**BOARD ACTION REPORT – APPEALABLE ITEM**

**Project Name:** Delray Ford  
**Project Location:** 2501 South Federal Highway  
**Request:** Class III Site Plan Modification Landscape Plan, and Architectural Elevations associated with the construction of a full service automobile dealership.  
**Board:** Site Plan Review and Appearance Board  
**Meeting Date:** February 28, 2018

**AGENDA ITEM:** **Delray Ford (File #2017-228)** – Class III Site Plan, Landscape Plan and Architectural Elevations associated with the construction of a 221,111 square foot automobile dealership at 2501 Federal Highway.

EXTERIOR  
COLOR ELEVATIONS

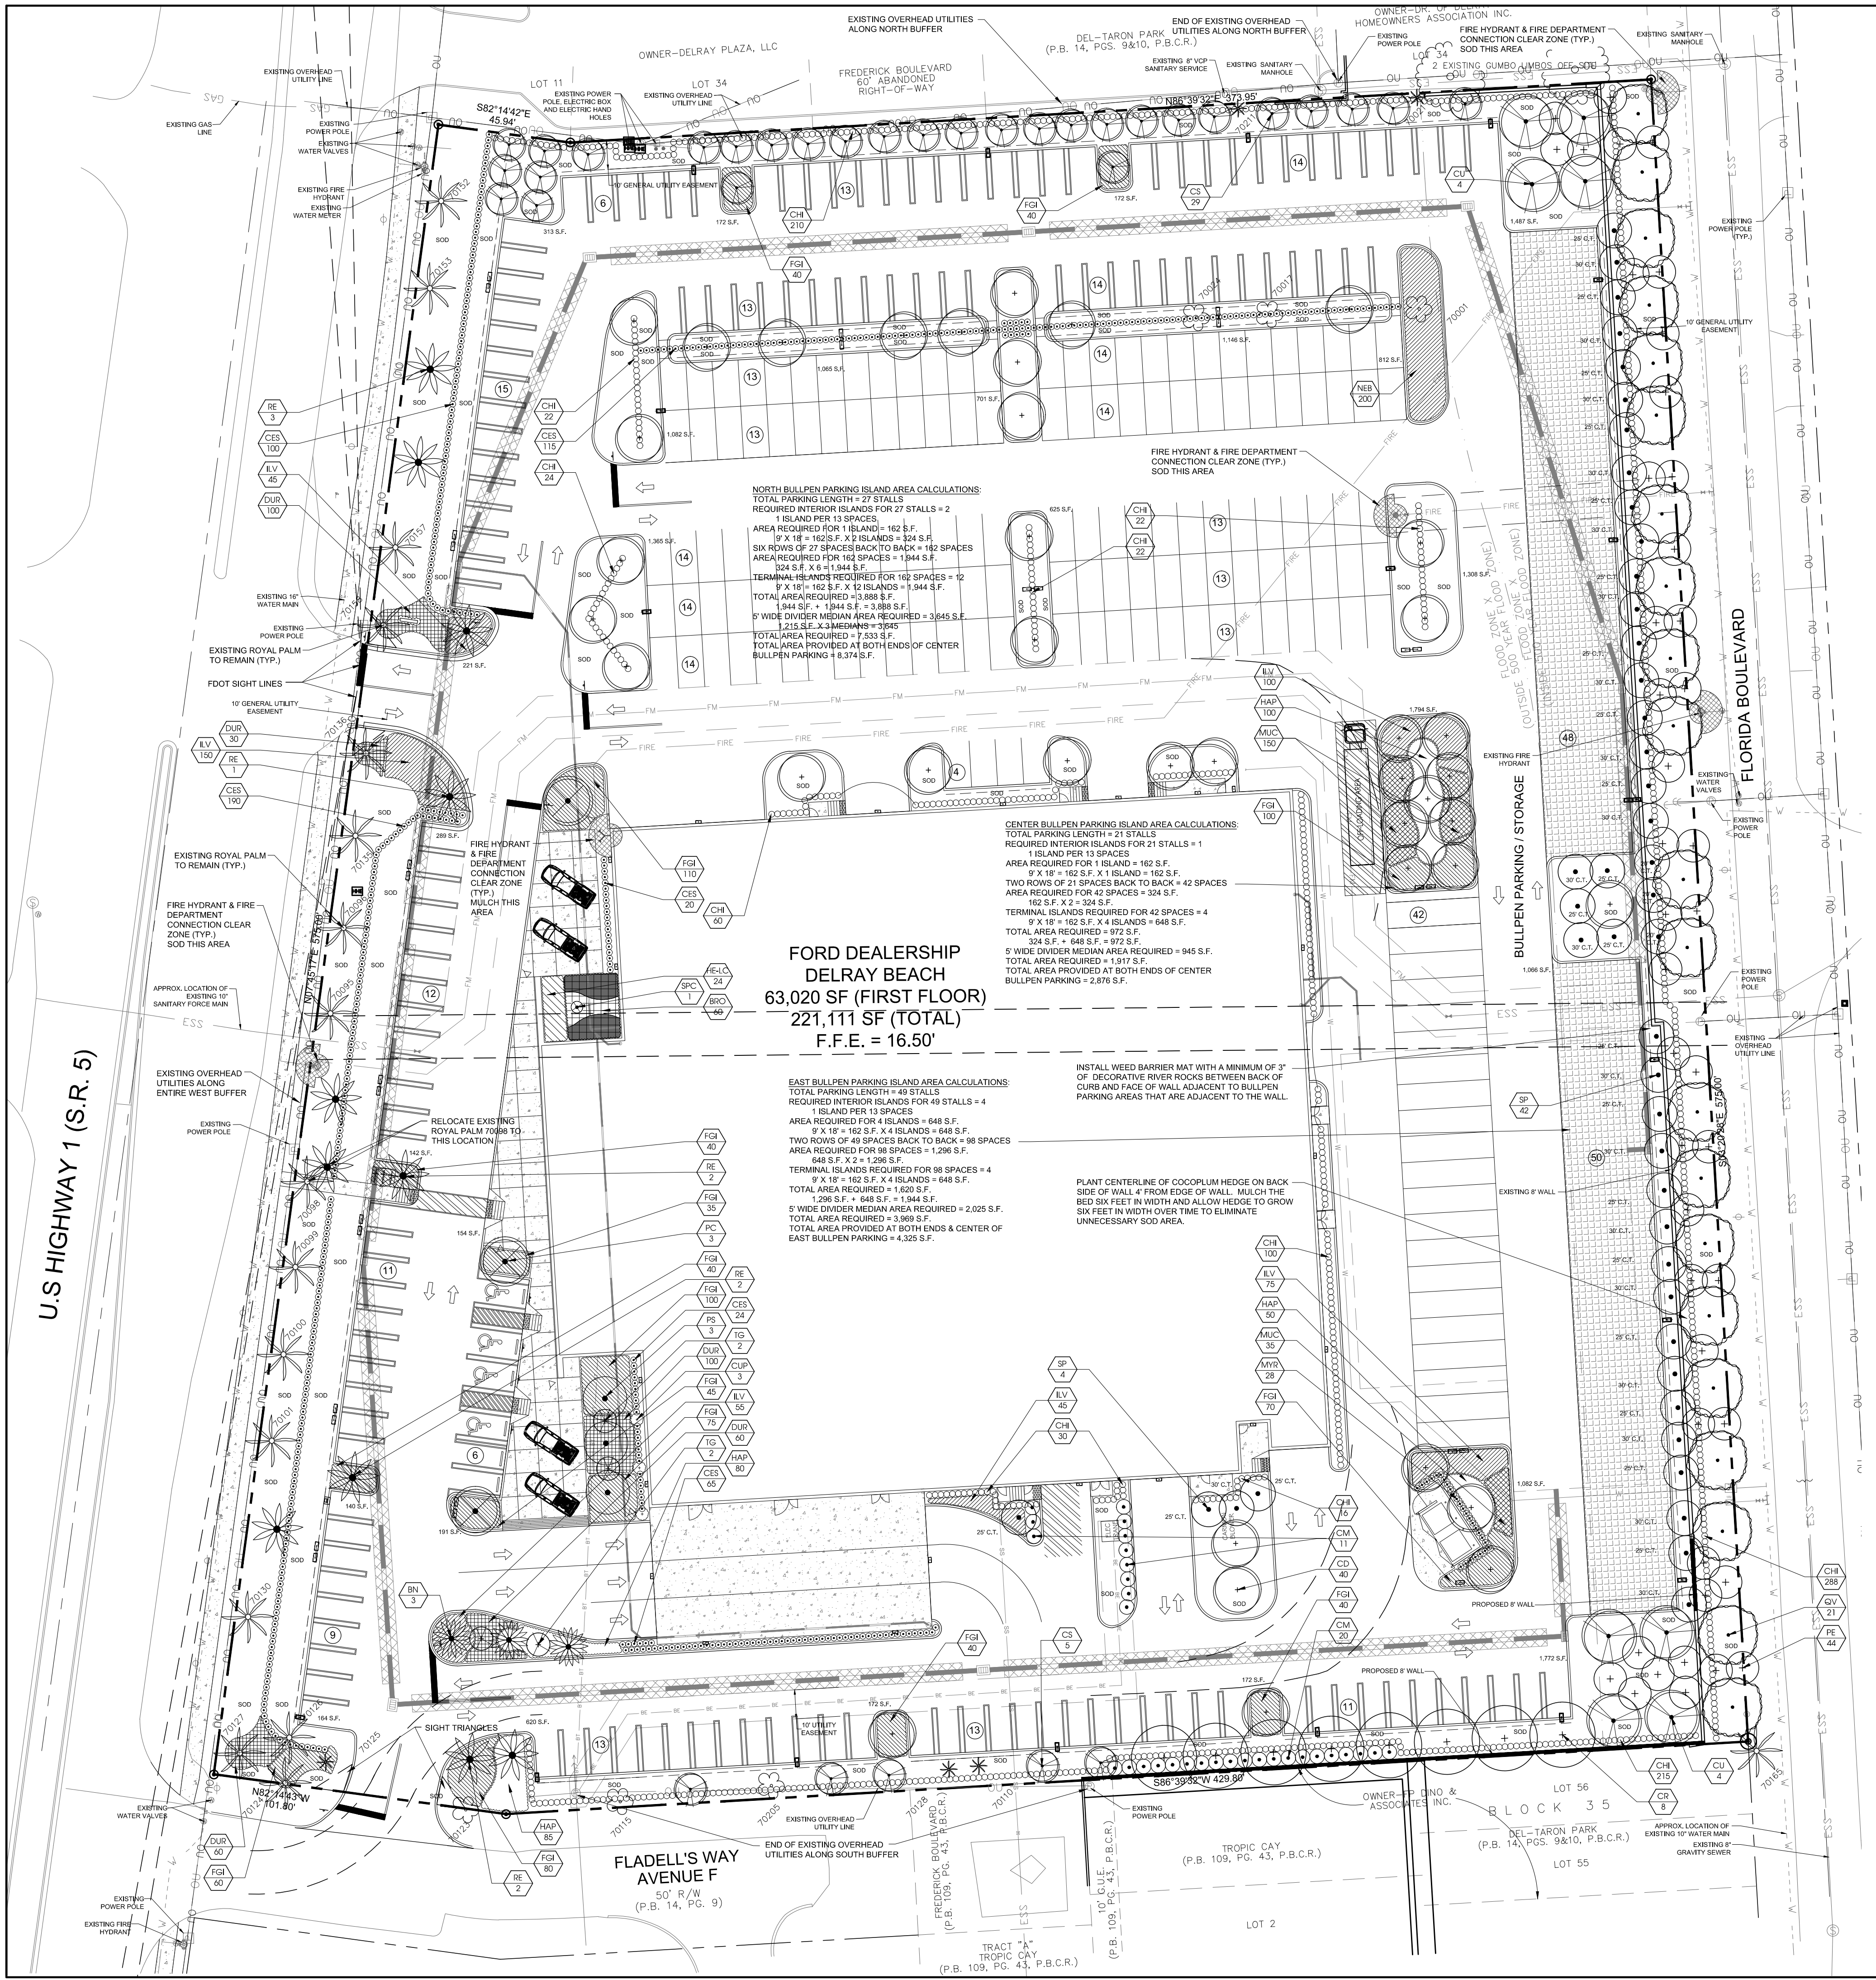
The proposed building is modern in appearance with primarily straight lines and a stylistically appropriate level of embellishment with a neutral color palette. This style is consistent with the use and surrounding development of the same nature. Glass and ribbed metal panels are used as accents to the primarily masonry structure.

The roof height is varied to avoid a continuous roofline. The flat roof includes parapets to hide the rooftop inventory parking and mechanical equipment. Portions of the parapet are decorative with additional detail, and the rear façade incorporates sloped parapets that mimic residential rooftops. The break in flat lines is intended to reflect the building's context and is considered a favorable design addition.

Overall, this structure is harmonious with surrounding development and demonstrates contextual awareness. Based on the above, a positive finding can be made with respect to LDR Section 4.6.18(E).
